Q&A #1

Bid Q&A

Question #:*0001*
BDR.47638

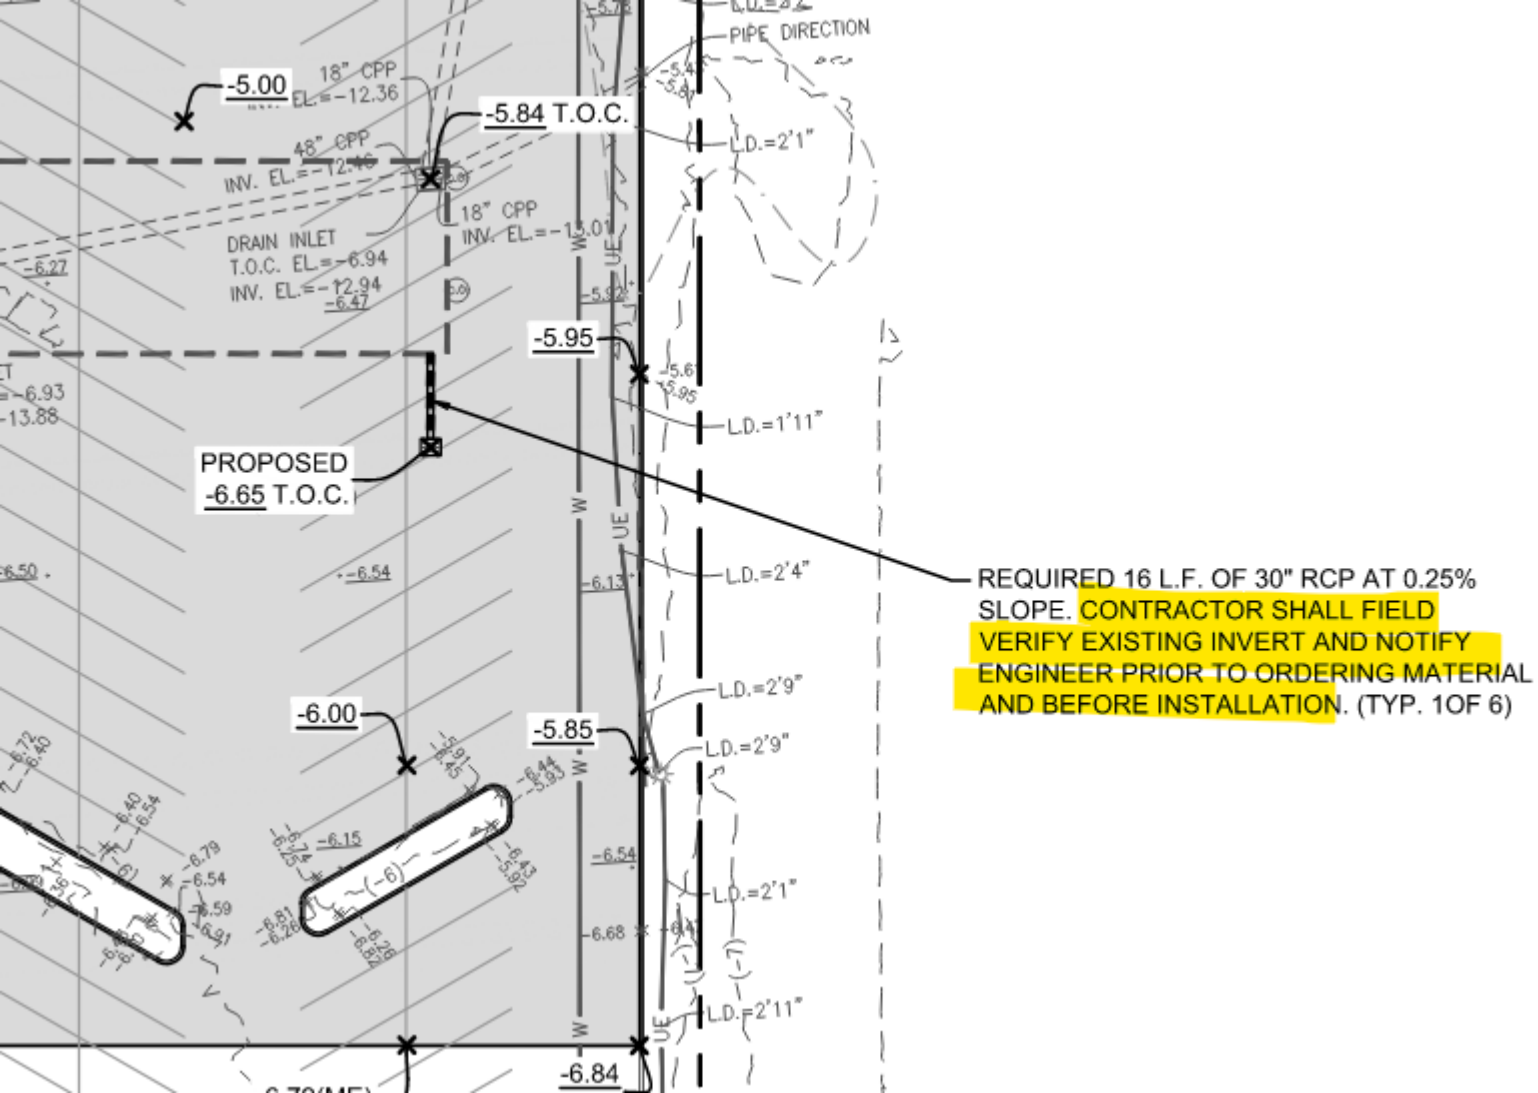
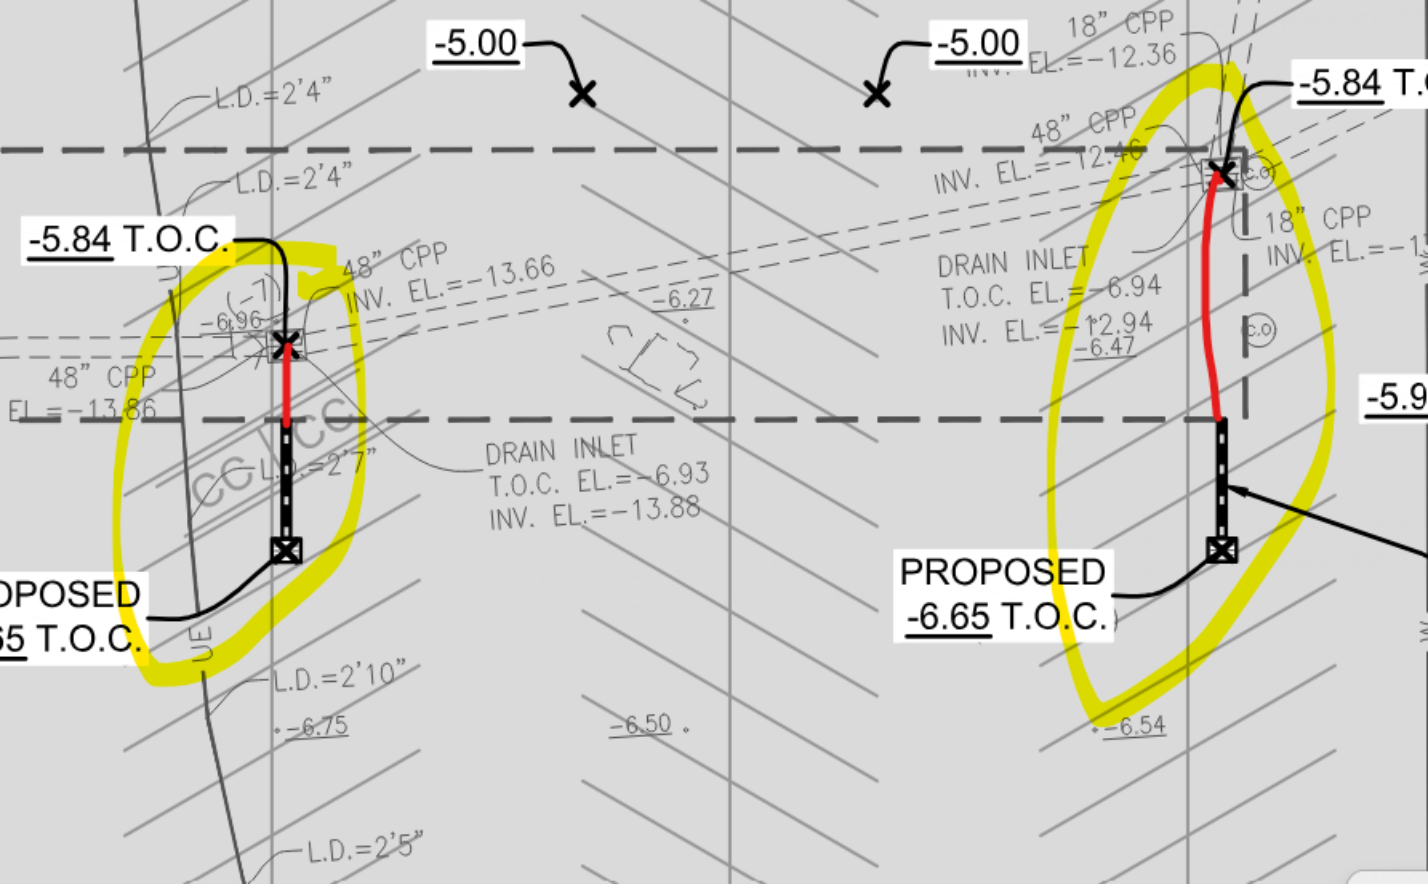
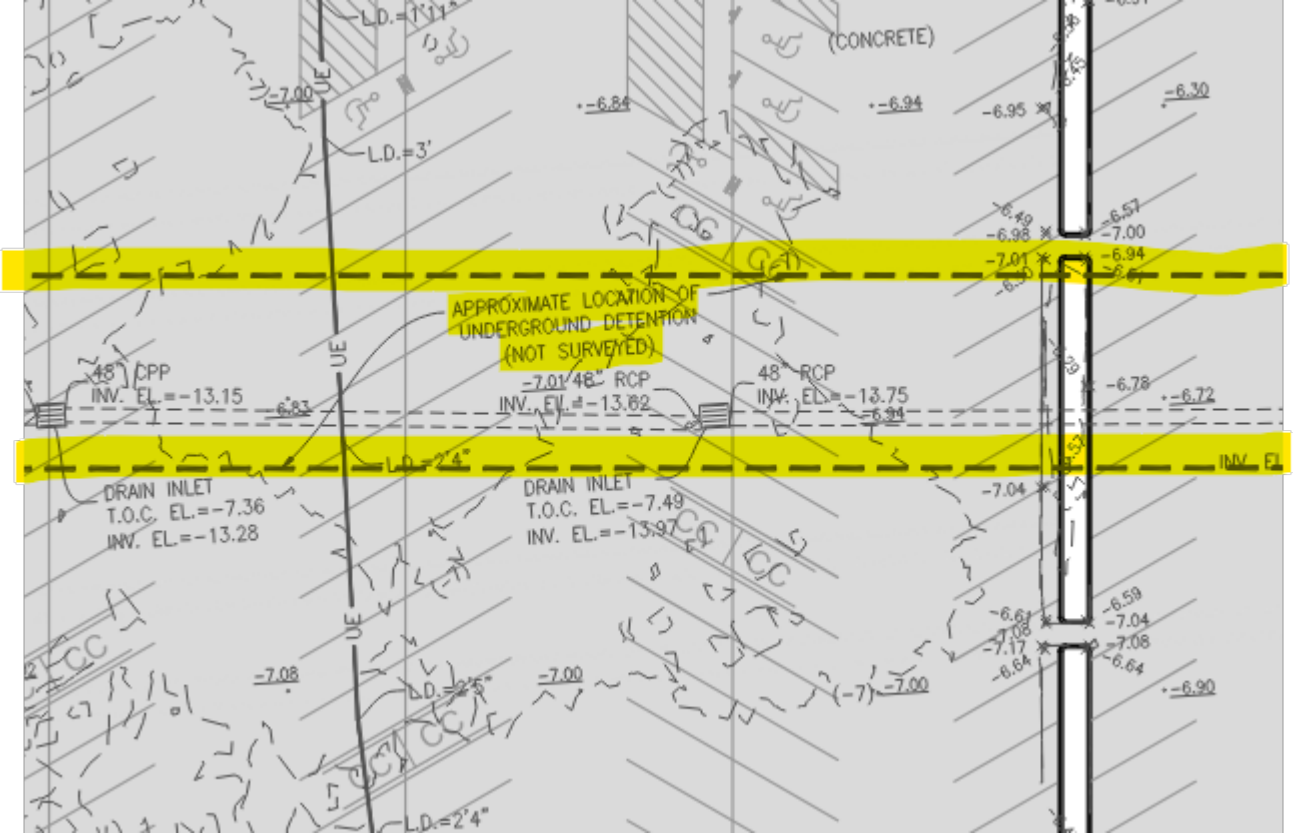
Title: Subsurface Drainage
Question: Sheet C-2 shows 6 new catch basins and associated storm drainage piping; however, the new pip is not show extending to the existing catch basins. What is this new pipe connecting to?

The dashed area indicates the limits of an existing underground detention system. The proposed drainage piping will tie-in to the existing system, which will need to be field verified prior to ordering material and before installation. See notes on Sheets C-2 and C-3.

-5.00
18" CPP
EL.=-12.36
-5.84 T.O.C.
48" CPP
INV. EL.=-12.46
18" CPP
INV. EL.=-13.01
DRAIN INLET
T.O.C. EL.=-6.94
INV. EL.=-12.94
-6.47
PIPE DIRECTION
L.D.=2'1"
-5.95
L.D.=1'11"
PROPOSED
-6.65 T.O.C.
L.D.=2'4"
REQUIRED 16 L.F. OF 30" RCP AT 0.25% SLOPE. CONTRACTOR SHALL FIELD VERIFY EXISTING INVERT AND NOTIFY ENGINEER PRIOR TO ORDERING MATERIAL AND BEFORE INSTALLATION. (TYP. 1OF 6)
-6.00
-5.85
L.D.=2'9"
L.D.=2'9"
L.D.=2'1"
L.D.=2'11"
-6.84
W
UE

L.D.=1'11"
(CONCRETE)
-7.00
UE
-6.84
-6.94
-6.95
-6.30
L.D.=3'
-6.49
-6.57
-6.98
-7.00
-7.01
-6.94
APPROXIMATE LOCATION OF
UNDERGROUND DETENTION
(NOT SURVEYED)
48" CPP
INV. EL.=-13.15
-6.83
-7.01 48" RCP
INV. EL.=-13.62
48" RCP
INV. EL.=-13.75
-6.94
-6.78
-6.72
L.D.=2'4"
INV. EL
DRAIN INLET
T.O.C. EL.=-7.36
INV. EL.=-13.28
DRAIN INLET
T.O.C. EL.=-7.49
INV. EL.=-13.97
-7.04
-6.59
-7.04
-7.08
-7.17
-7.08
-6.64
-6.64
-7.08
-7.00
L.D.=2'5"
-7.00
-6.90
L.D.=2'4"
